CLASSEN ROAD
P.O.A.D.P.

INFORMATION SHEET FOR
PRELIMINARY OVERALL AREA DEVELOPMENT PLAN
(P.O.A.D.P.)

RE: Classen Road POADP
File #83-18-63-68
(Revised January 7, 1986)

Re: Classen Road ☐ Preliminary Plan
☒ P.O.A.D.P.
File #: 83-18-63-68 Revised 10/3/83

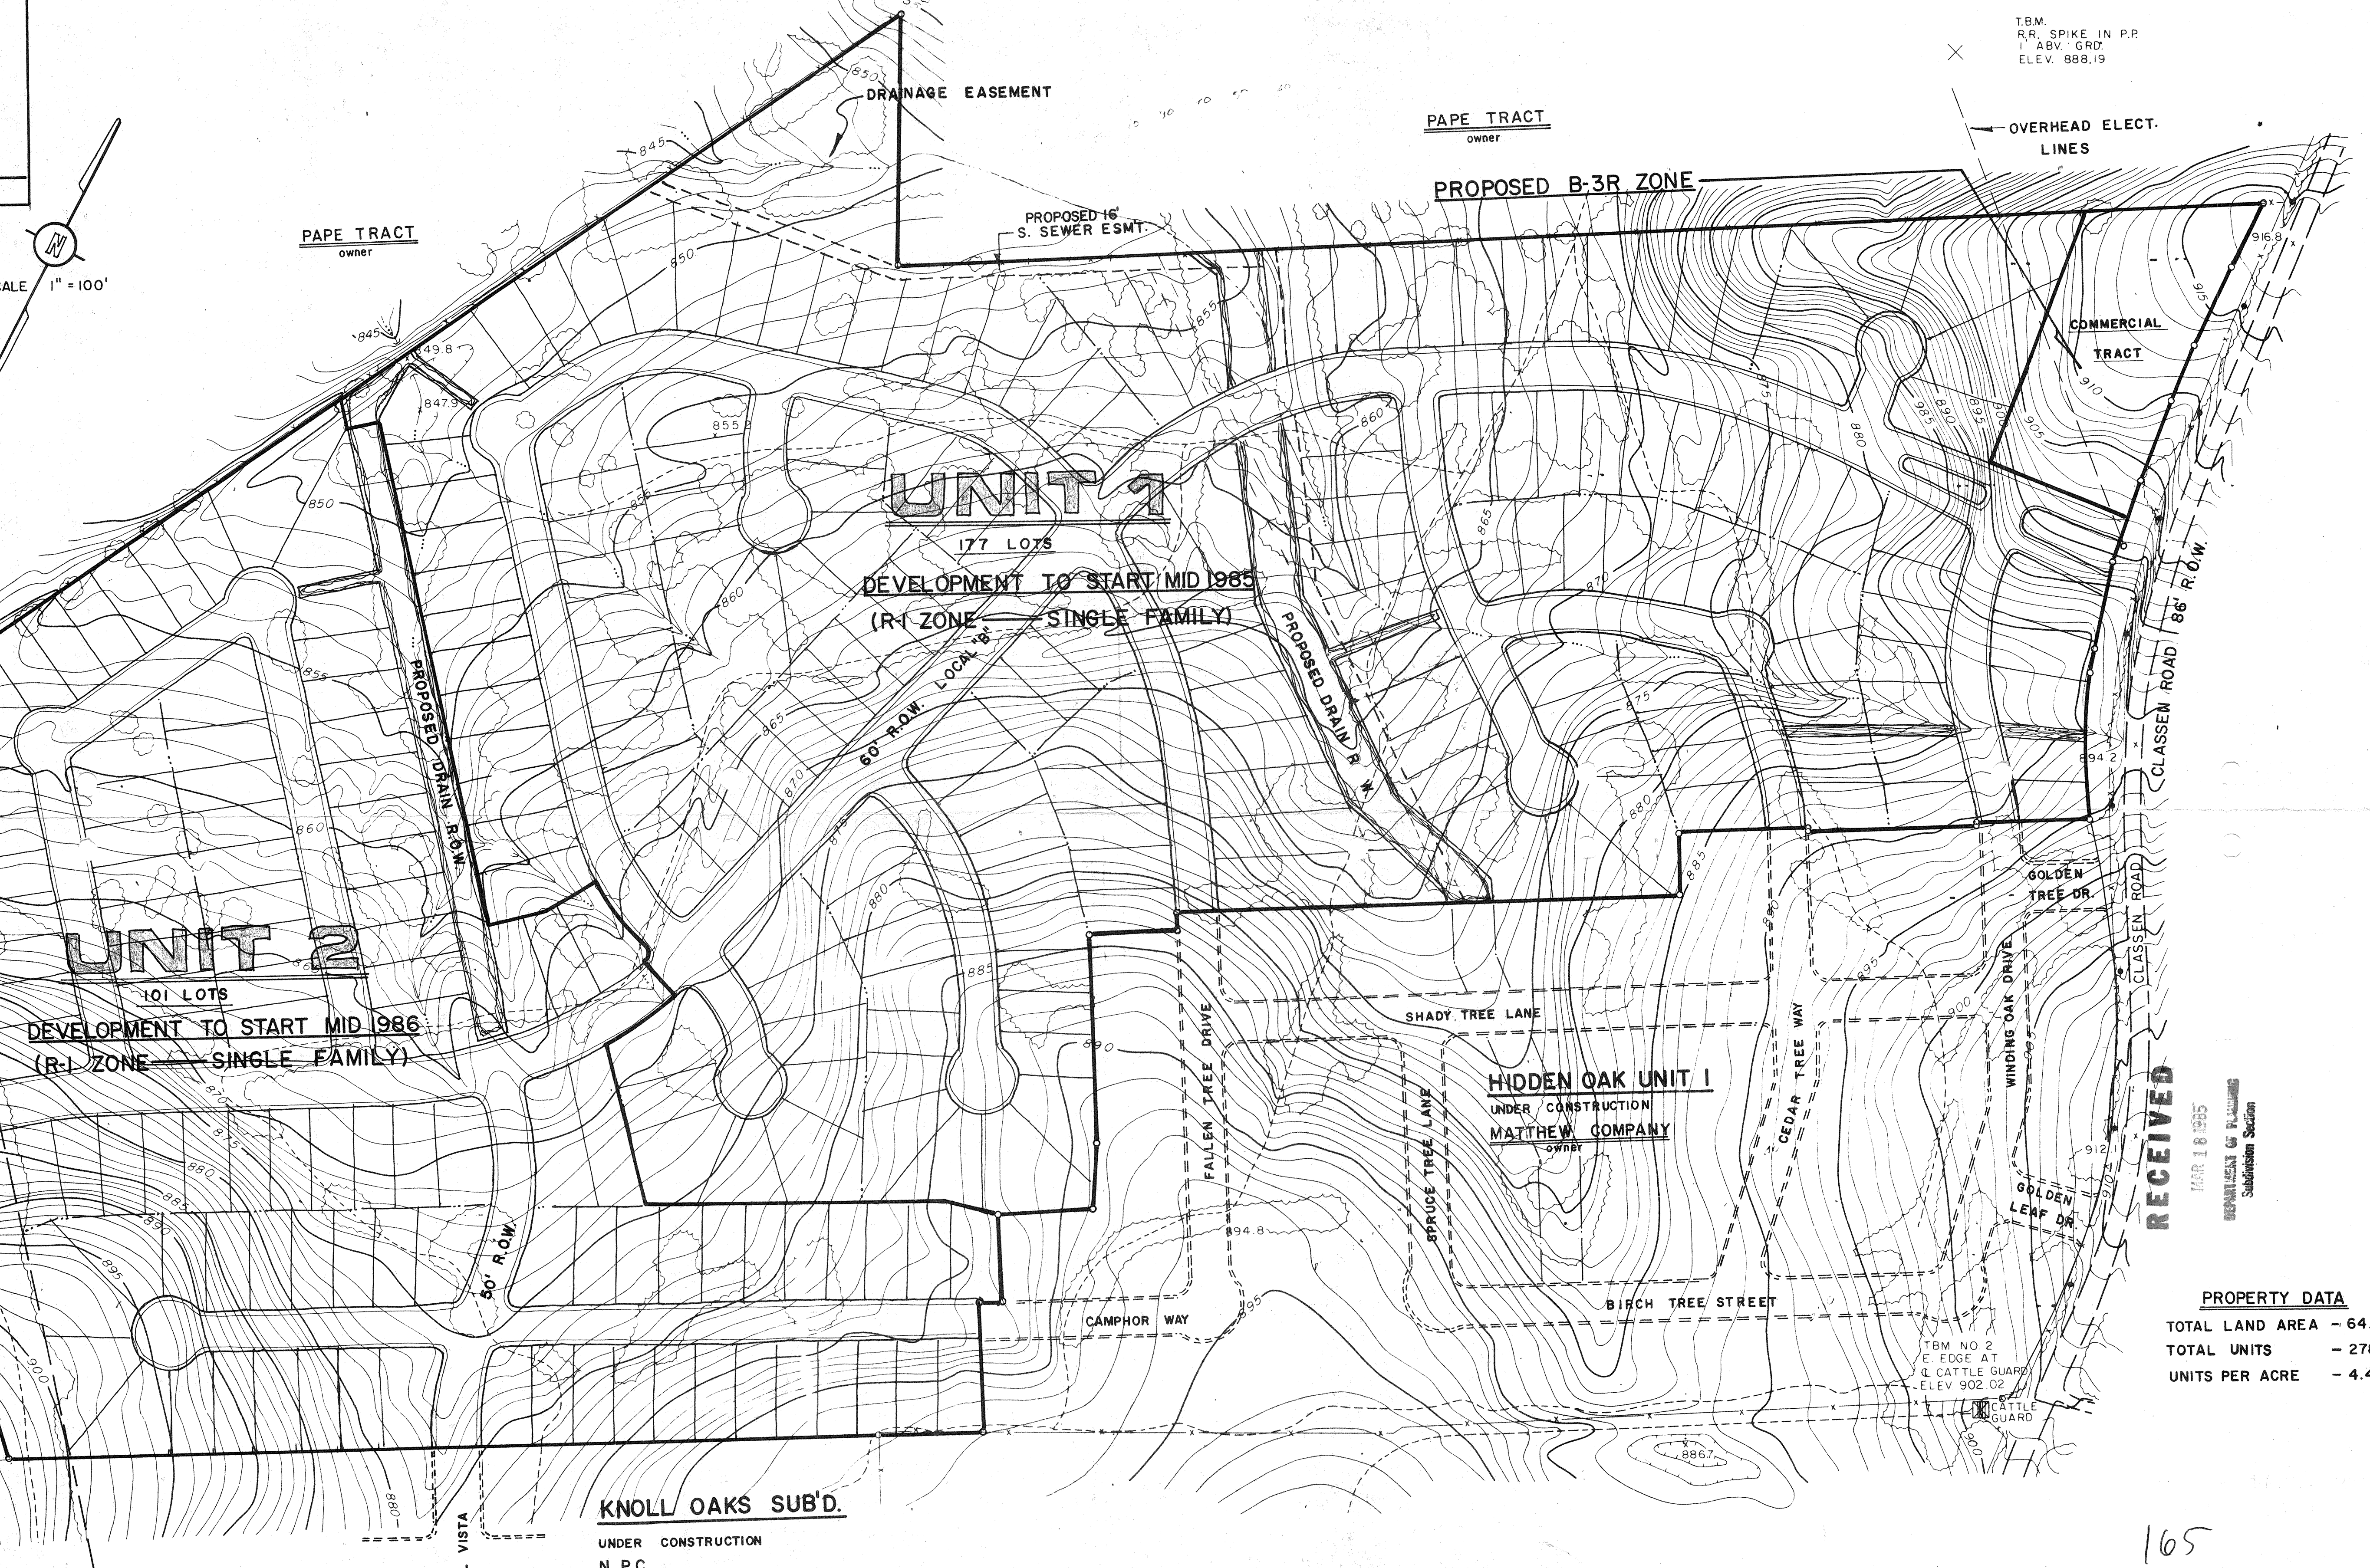
On January 10, 1986, the POADP Committee reviewed the revised Classen Road POADP and determined not to accept the plan which establishes a future unit for approximately 100 linear feet of new street and two (2) lots.

With the future unit consisting of only two residential lots in addition to the 100' street extension within the CPSB easement, there is very little incentive for you to construct the street. The Committee sees this resulting in either of two unacceptable situations:

1. Without the extension of the Local "B" street to the limits of your property, there will be no means to require the adjacent developer to provide a street to be into the Local "B".
2. If in fact the adjacent developer should provide a stub street to the edge of his property, the city may be required to actually construct the missing 100' if it wishes to see the two sections connected.

The Committee proposes two (2) alternatives:

1. Alternative "A", that your proposed plat for Unit-2 follow the boundaries of your initial POADP plan.
2. Alternative "B" provide an elbow and extend a 60' R.O.W. to Knoll Vista Drive (see attached plan for details).

- () is in general compliance with the Subdivision Regulations
- (x) lacks compliance with the Subdivision Regulations regarding:
- | | |

| (x) Stub streets | () 24' alley(s) |
